Subject: Addendum to Geotechnical Engineering Report, New Residence,
3064 – 68th Avenue SE, Mercer Island, Washington.

Reference: Geotechnical Engineering Investigation, New Residence, 3064 – 68th Avenue SE,
Mercer Island, Washington. GEO Group Northwest, Inc., May 9, 2022.

SUMMARY OF GEOTECHNICAL REVIEW COMMENTS

**TEMPORARY BLOCK WALL
SHORING DETAIL**

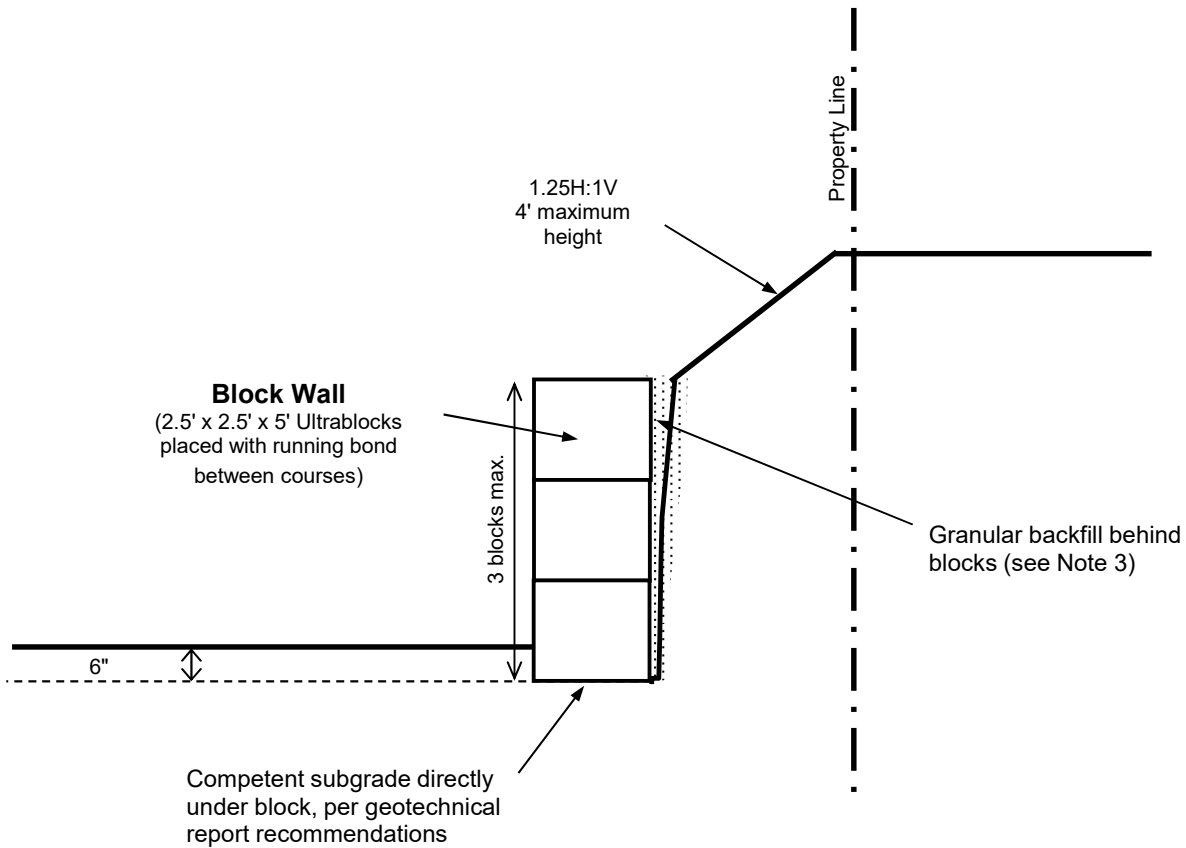
This temporary cut slope angle is steeper than recommended by the geotechnical engineer (p.9 of report). Geotechnical engineer to provide slope stability analyses of proposed open cut to verify that adequate FS exists. Alternatively, provide temporary shoring recommendations.

Geotechnical engineer to review proposed temporary open cut and provide assessment as to whether this cut can be made as shown given anticipated subsurface conditions. Alternatively provide temporary shoring recommendations in a report addendum that does not encroach on the adjacent property.

We understand that a portion of the northeast corner of the temporary excavation for constructing the new residence will need to be supported because of the lack of available space on the property for an open cut consistent with our recommendations. The height of the supported portion of the cut is planned to be 5 feet, and the length of the supported cut is planned to be approximately 10 feet. For this situation, temporary support can be provided by using modular concrete blocks such as Ultrablocks or similar product. A section profile for the proposed cut with shoring is presented in Plate 2 – Temporary Block Wall Shoring Detail.

- The blocks should have minimum dimensions of 2.5 feet square ends by 5 feet length (for full-size blocks) and of 2.5 feet square ends by 2.5 feet length (for ‘half-blocks’ where used). The blocks should have interlocking top and bottom keys for improved stability when stacked. The blocks should be on site and ready for use when cuts steeper than 1.25H:1V are initiated.
- The wall can be constructed to have a maximum height of three blocks with a rising backslope that does not exceed an inclination of 1.25H:1V and a height of 4 feet.

- The blocks should be stacked in an interlocking, running bond pattern. Half-length blocks should be used where appropriate to form vertical ends to wall lengths where needed to retain soil.

- The wall can be constructed with a vertical face. An embedment of 6 inches is recommended for providing a measure of supplemental stability.
- The bottom row of blocks should be set on a smooth, competent subgrade surface. A crushed rock base course, such as 5/8"-minus crushed rock, can be placed on the subgrade if desired to provide an even surface for stacking the blocks.

- The wall should be constructed in a single pass, beginning at one end and progressing to the opposite end, with excavation and block placement being performed in short intervals. We recommend that the length of unsupported excavation be limited to 10 feet (the equivalent of two block lengths) while the work proceeds. Excavation of slopes to inclinations steeper than 1.25H:1V should not begin until the blocks are present on site.

- Void areas behind the wall should be filled during installation to provide wall and ground stability. The backfill should consist of granular material that is free of clumps or deleterious materials (e.g., debris, organics, etc.). We anticipate that an imported material, such as a sand and gravel pit-run will need to be used as backfill instead of the site soils (subject to the review of the geotechnical engineer).

- Unsupported excavations steeper than 1.25H:1V should not be exposed longer than necessary to promptly place the blocks and should not be left exposed overnight.

Temp Excavation Profile B

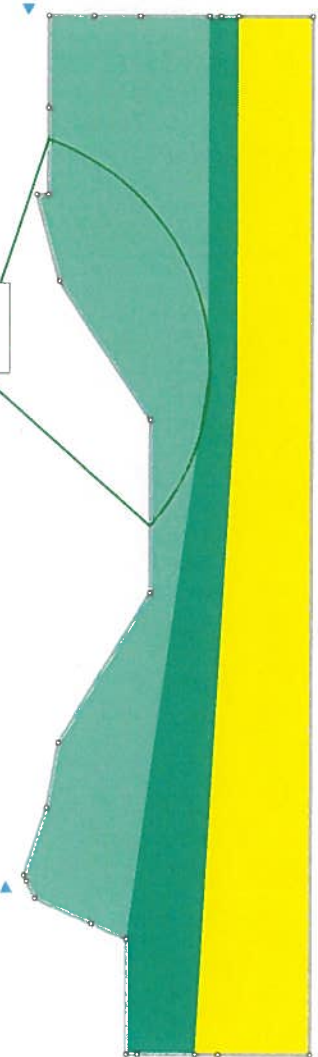
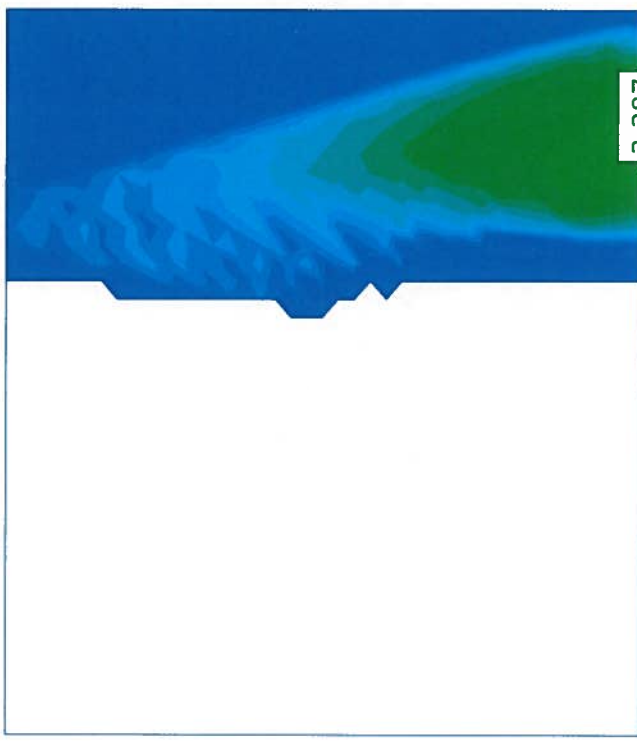
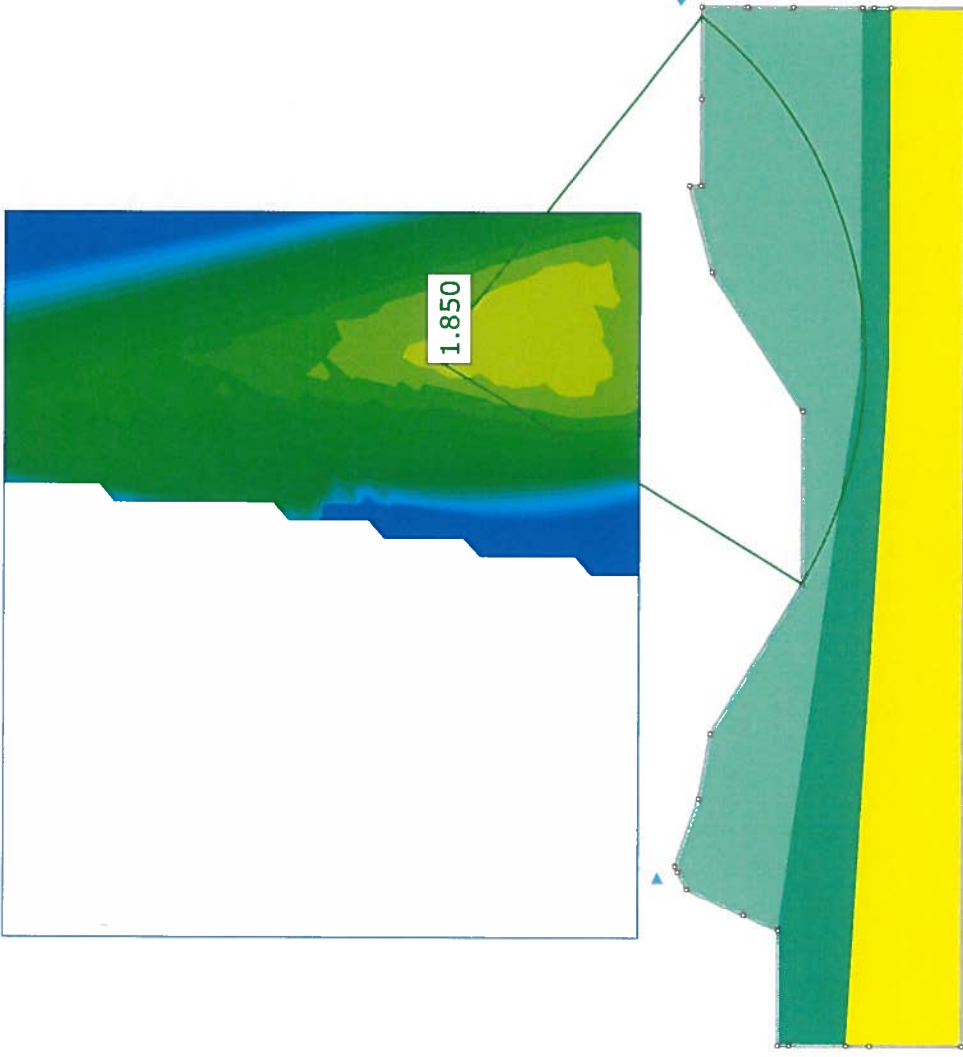
Please provide slope stability analyses of maximum proposed temporary open cuts, e.g., as required to construct sections 1/A301, 2/A301 and 1/A401. Provide alternate means to support the excavation if slope stability analyses indicate marginally stable or unstable open cut conditions.

The analysis results indicate acceptable factors of safety for the proposed temporary cuts and for the proposed post-construction configuration in our opinion. The proposed temporary cuts were found to have factors of safety of 1.90 in the east-west profile (profile C) and of 3.38 in the north-south profile (profile B). The post-construction configuration for the proposed project was found to have factors of safety of 1.93 under static conditions and of 1.23 under dynamic conditions.

G-5713 C post construction.slm

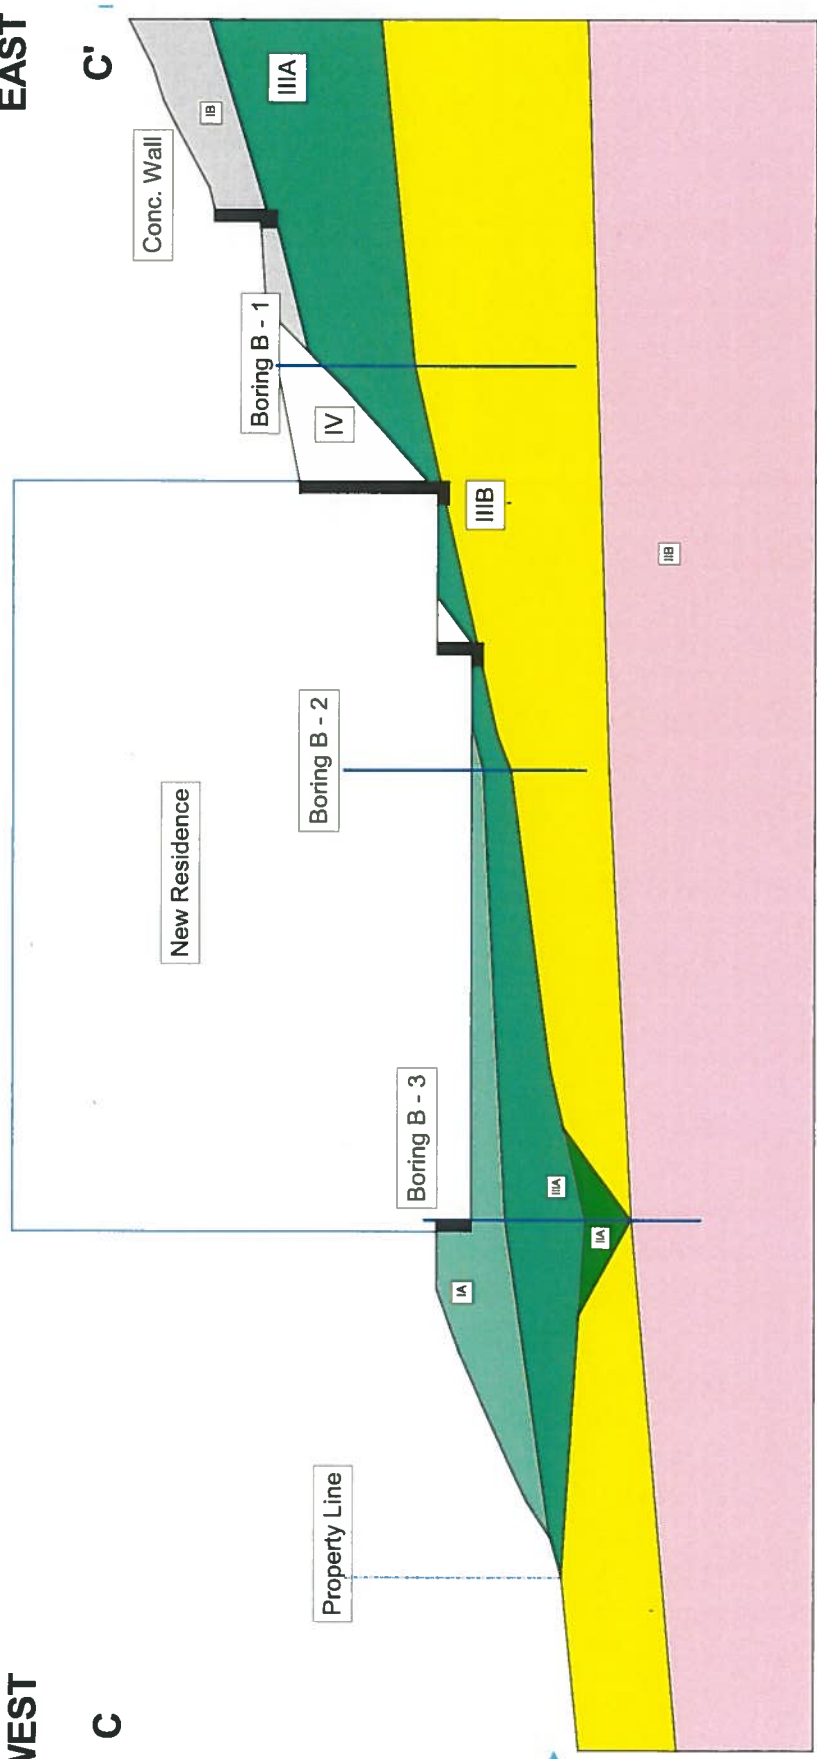
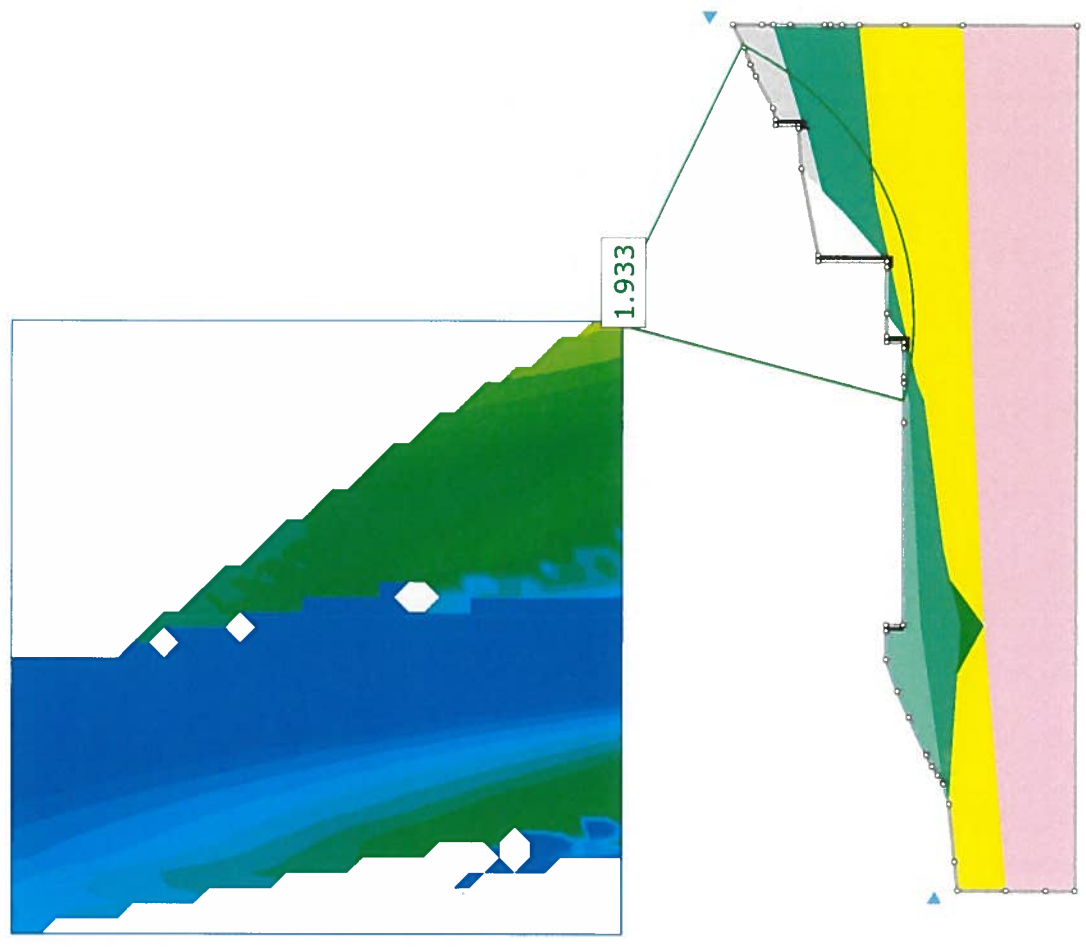
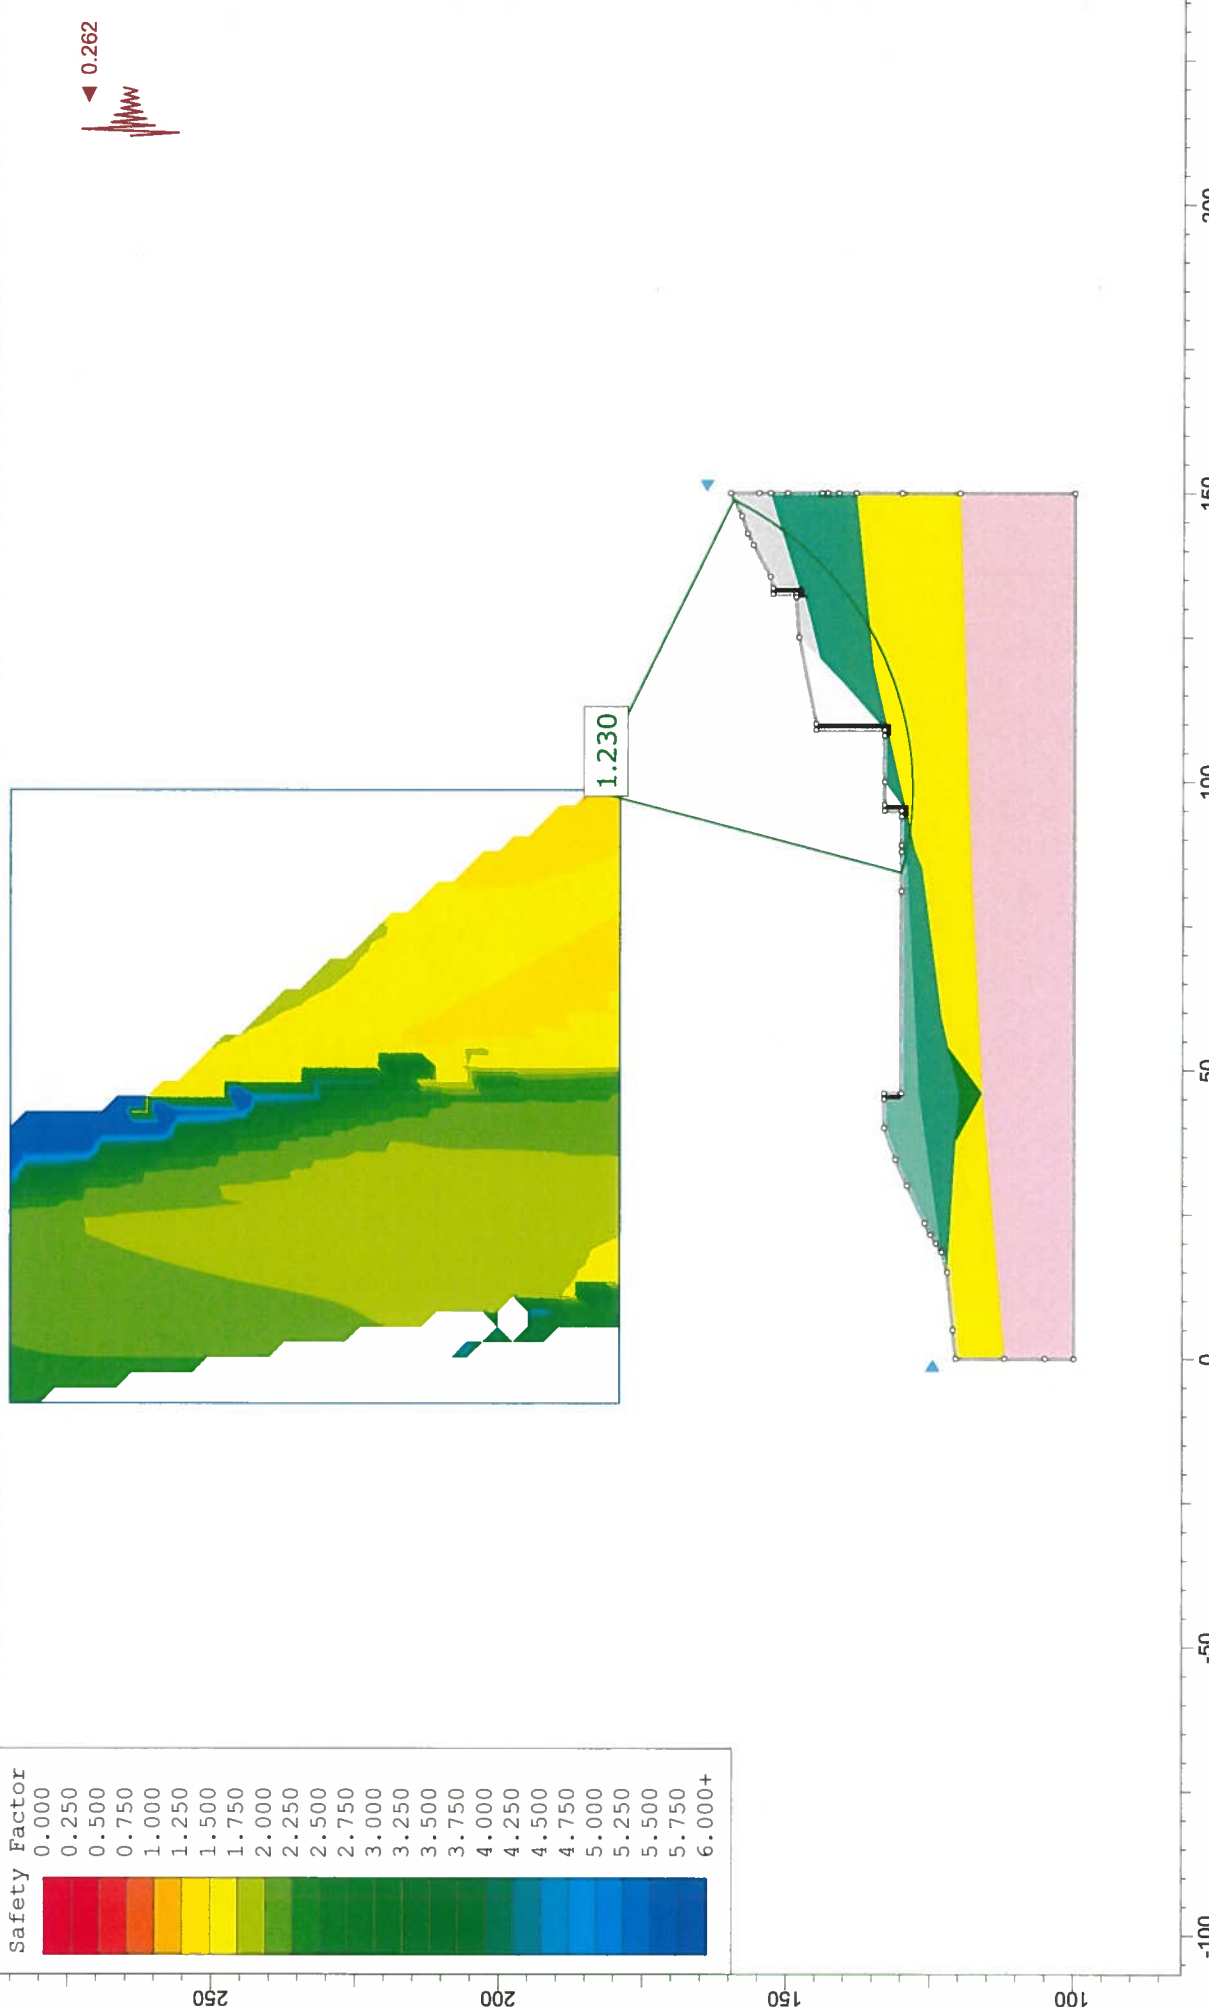
Please provide supporting documentation for the use of a seismic coefficient of 0.2 in the seismic slope stability analyses. IBC requires the use of MCE loading in determining the seismic coefficient as opposed to a design earthquake loading. Using 1/2 of the MCE acceleration to determine the seismic coefficient would result in a value higher than 0.2. Please revise analyses accordingly or provide supporting documentation and calculations for an alternative determination of the seismic coefficient in order to use 0.2.
